BID NO. 2024-25.10
WILSON HIGH SCHOOL: MEDIA CENTER UPGRADE
February 11, 2025
ADDENDUM NO.01

ADDENDUM 01 Details

**WILSON HIGH SCHOOL
MEDIA CENTER REMODEL
HACIENDA LA PUENTE UNIFIED SCHOOL DISTRICT**

tBP Project No. 21211.00

drawing title:
REMODEL SIGNAL PLAN
drawing no.:
E-2.1
drawing of

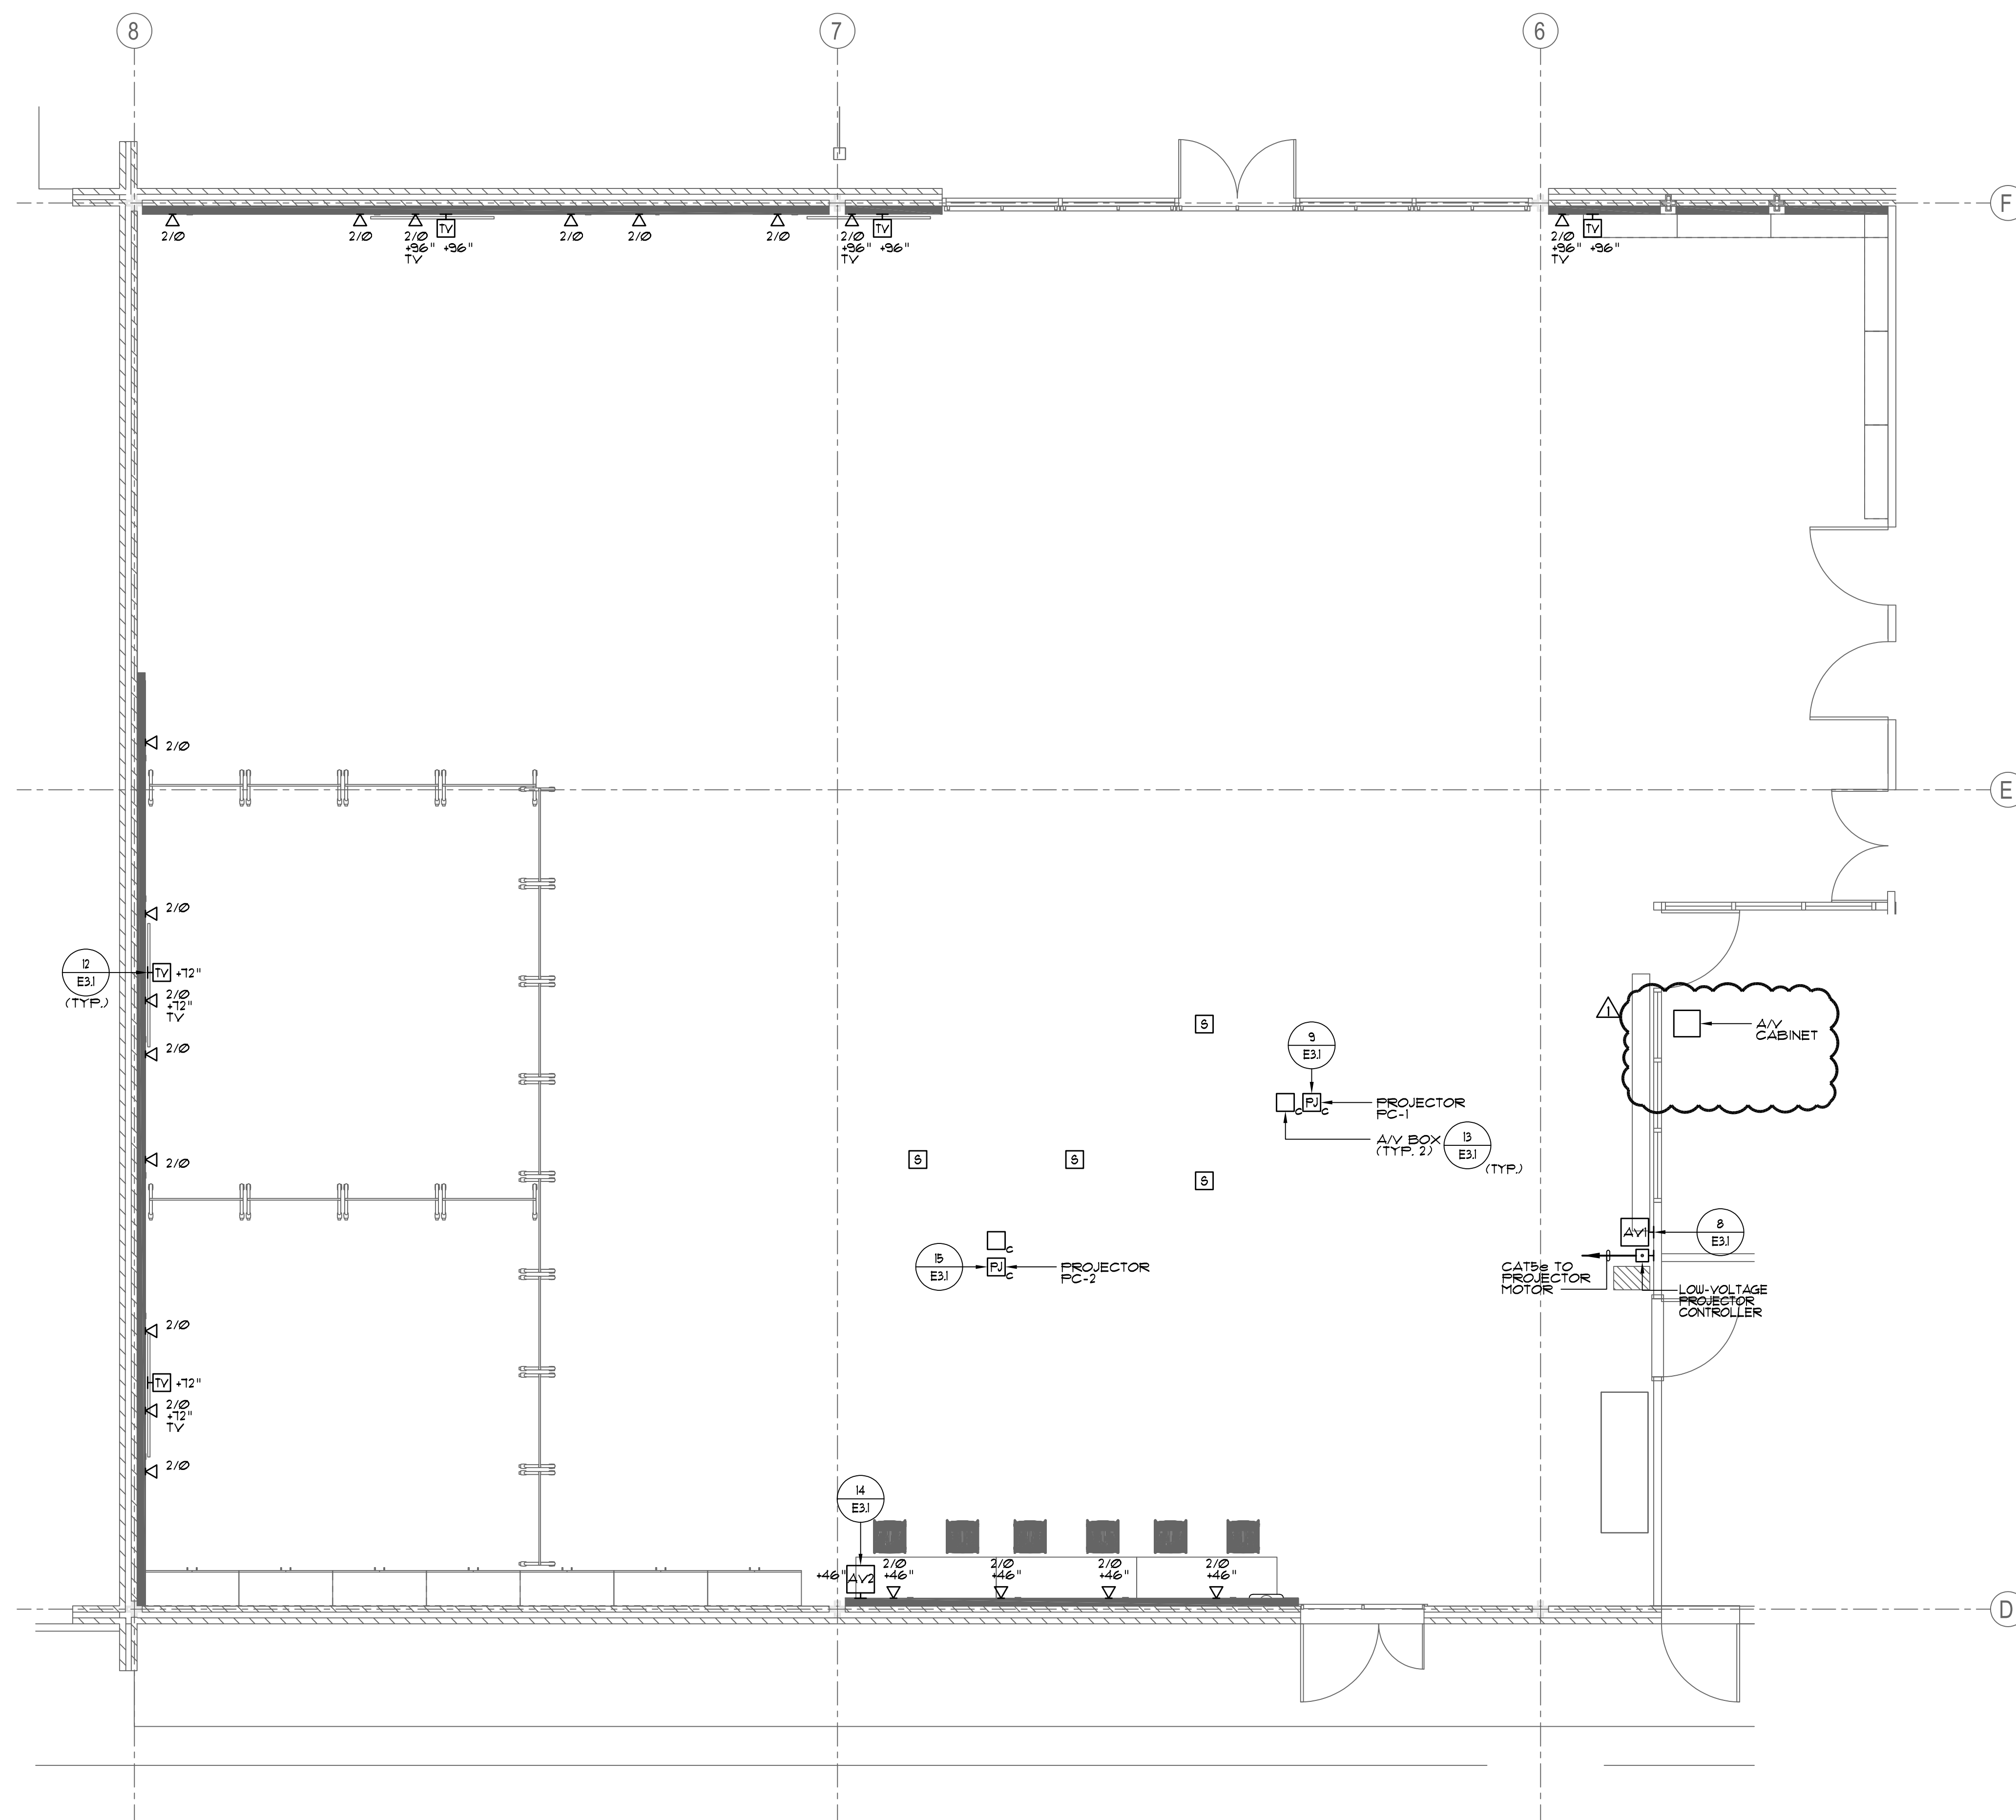
7. SHEET E-2.1 REMODEL SIGNAL PLAN
 - a. Added location of new AV cabinet.
 - b. Replace Sheet E-2.1 Remodel Signal Plan in its entirety issued with this addendum.

Sheet E-2.1 is showing (2) projectors and (5) flat panel displays but there is no indication if this is all one system or multiple. Please clarify.

Plan note #7 on sheet E2.1 calls out for an assistive listening system to be provided however it is not clear if each AV system should be provided with their own separate assistive listening systems. Please clarify how many ALS should be provided.

Response – Refer to sheet E3.1, A/V Outlet Diagrams and A/V Wiring Diagrams for system requirements. Projectors shall be interconnected and all flat panel displays are to be individually controlled. Projectors are to be mounted at a suitable height for the lenses to be aligned correctly to minimize parallax and image distortion.

Response – Note #7 indicates to provide quantities equal to 4% of the seating capacity, but in no case less than two receivers are to be provided. Refer to Architectural seating capacity to obtain quantities to be provided with a minimum of two receivers to be provided. Assistive listening devices shall be integrated into ceiling speakers. (A&F Engineering Group, Inc.)

A/V 1 OUTLET - FLUSH WALL MOUNTED

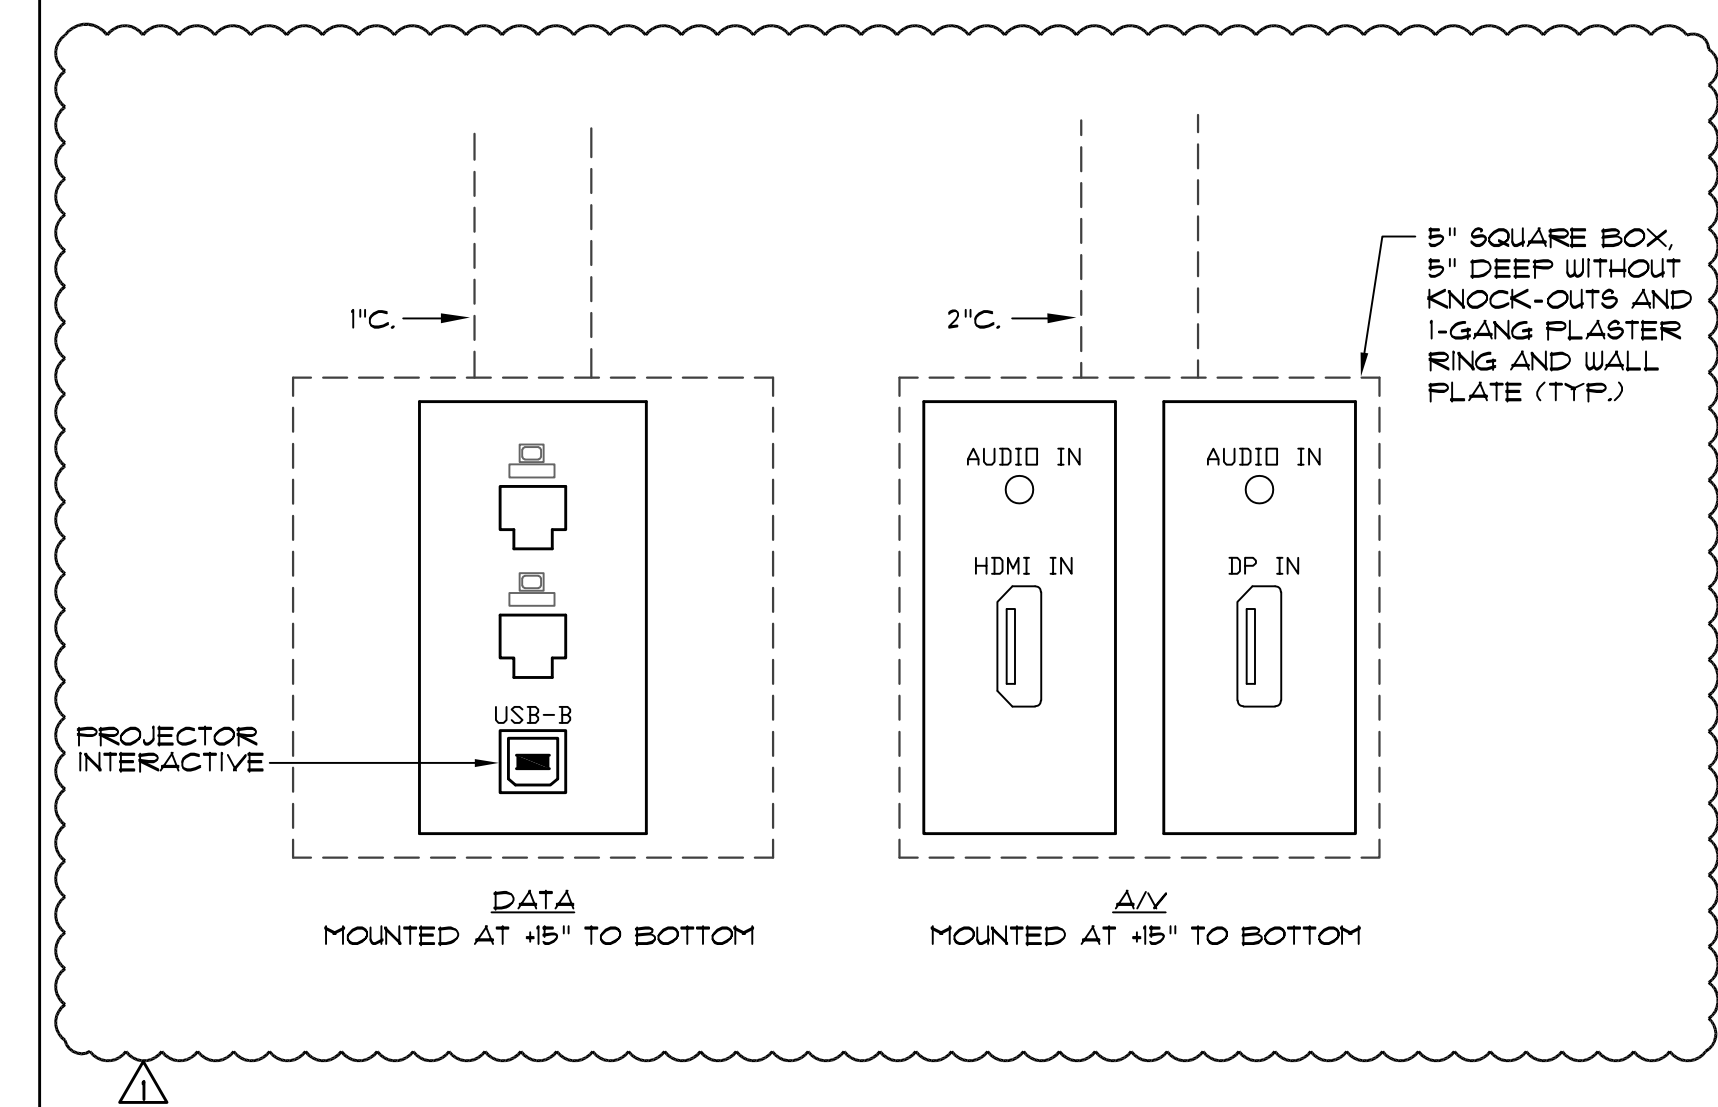
8. SHEET E3.1 ELECTRICAL DETAILS
 - a. Revise Details 8, 9, 13, 14, & 15.
 - b. Replace Sheet E-3.1 Electrical Details in its entirety issued with this addendum.

A/V PROJECTOR LAYOUT DIAGRAM

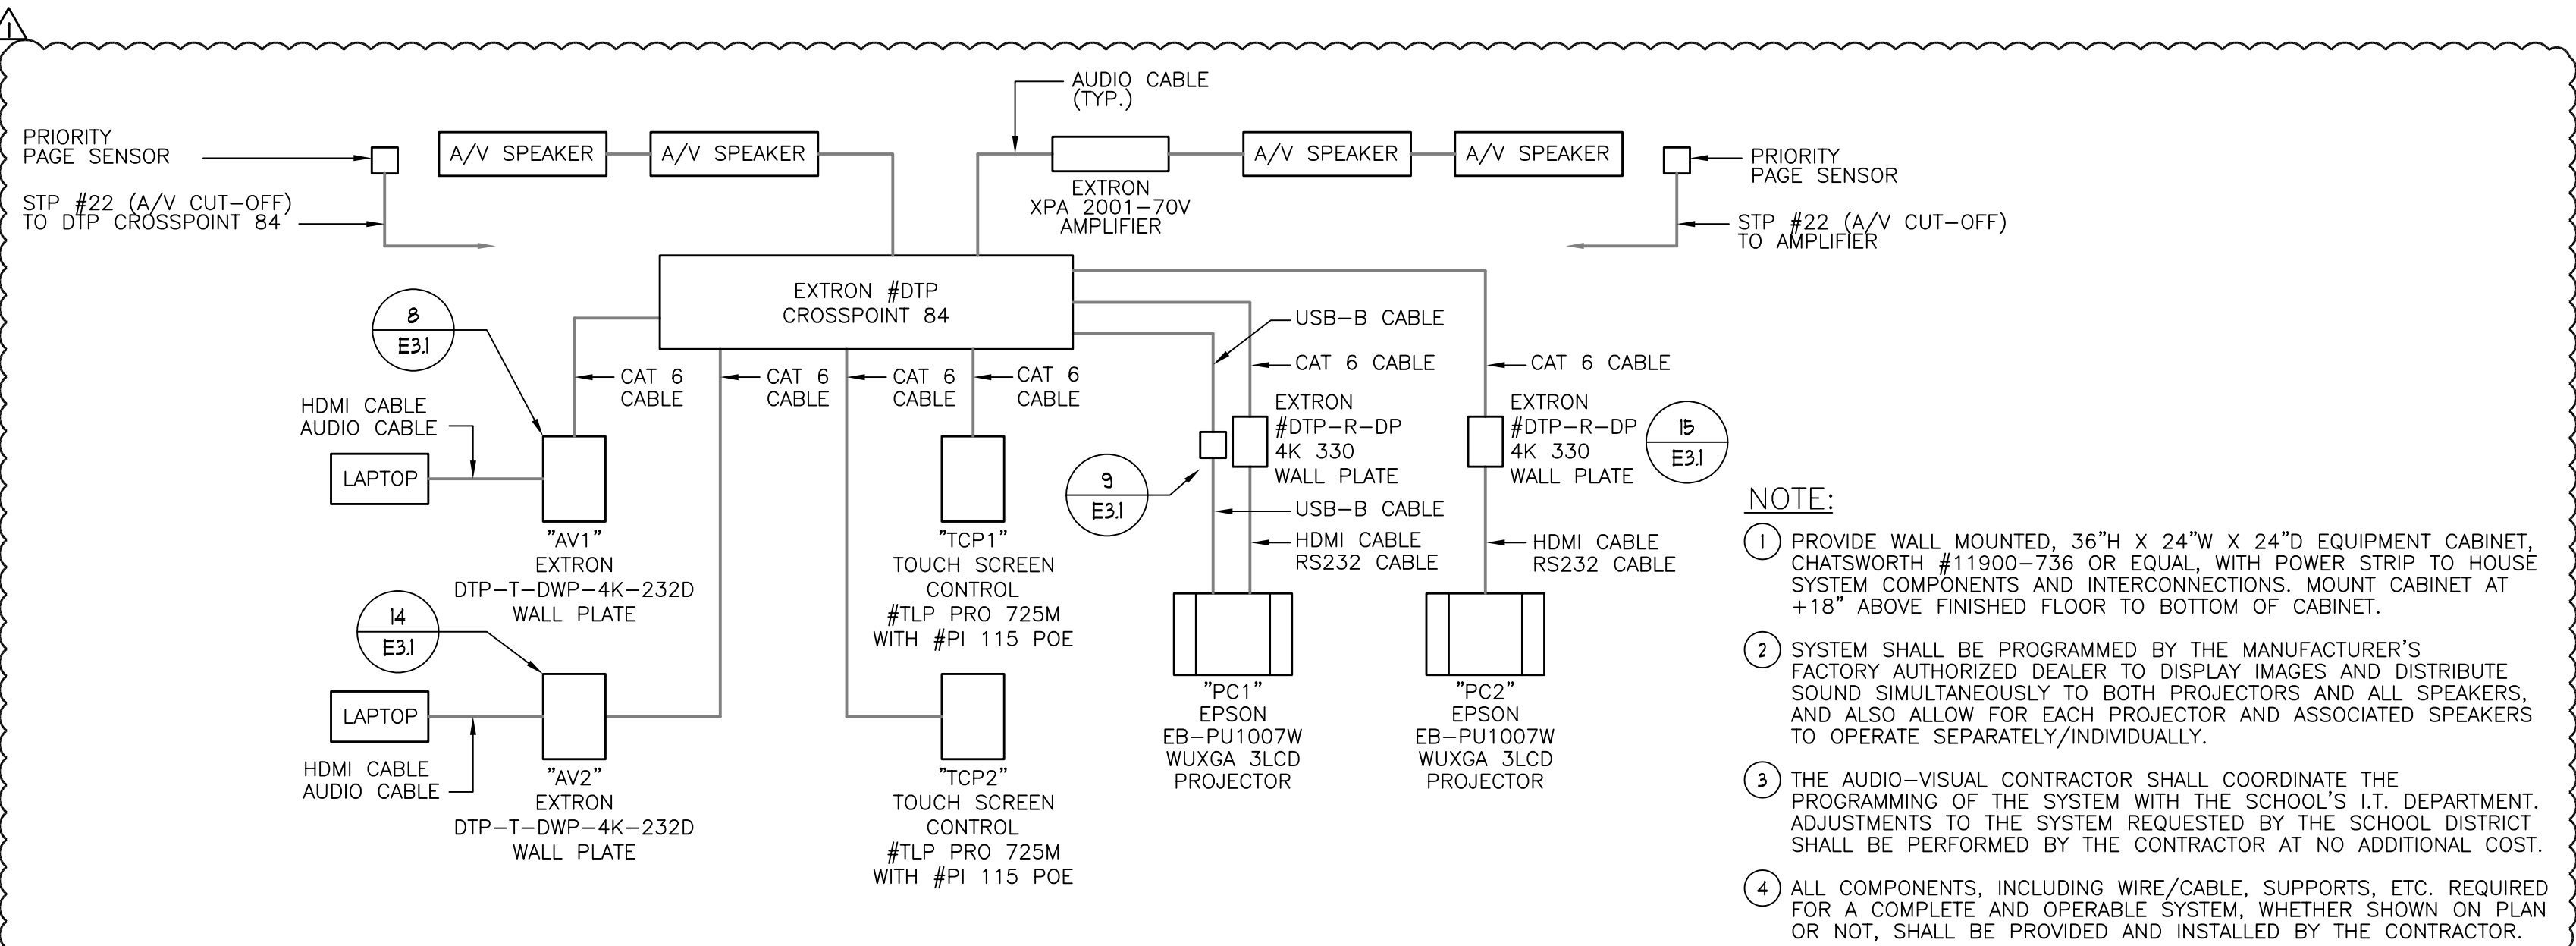
Please provide the missing AV wiring diagram that shows how the AV systems should be connected.

In the attached drawing, please clarify the intent of the following items:

- a. Priority page sensor, is this provided by the customer and we are just proving the #22 cable to the amplifiers and terminating to our amplifier?
- b. Internet TV, is this provided by the customer? If not, what are the specs and requirements needed?
- c. Microphone antenna, what are the specs and requirements needed?
- d. Splitter, what is the purpose of having two splitters on the same wire?

Response – Refer to sheet E3.1, detail #13 for A/V wiring diagram. (A&F Engineering Group, Inc.)

Response- a. Priority page sensor to be provided by Contractor.

b. Not required.

c. Not required

d. Refer to the revised wiring diagram on Sheet E3.1 attached to the addendum.
